FGI

Formal Interpretations *Guidelines for Design and Construction of Hospitals, 2018 edition*

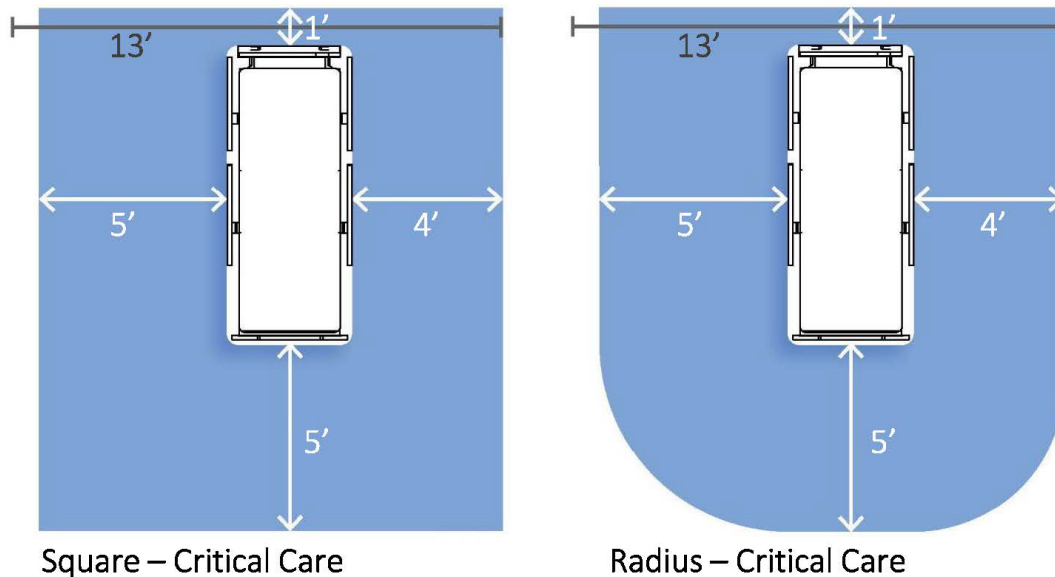
Question: In Section 2.2-2.6.2.2 (2), regarding clearances for critical care patient care stations, does the 5-foot clearance requirement at the foot of the bed only require clearance for the width of the bed itself, or is the clearance to be extended to include transfer side width (5 feet) and non-transfer side width (4 feet), such that the width of the clearance at the foot of the bed totals 14 feet?

Response: The clearance requirement at the foot of the bed is intended to create sufficient space for care of the patient. Space is needed around the corners of the bed to allow access and movement for equipment, staff, and family members. Staff must be able to easily move around the bed. As well,

space is needed for IV and pain management systems, warmers, etc., and for use of patient lifts and gurneys. To accommodate these needs, the full dimension at the foot needs to be as wide as the clearances on the sides of the bed; however, the squared-off space this creates could be rounded off to accommodate structural or other non-movable encroachments. This response applies to all places in the *Guidelines* where clearance requirements are provided. The diagrams below may help clarify this response.
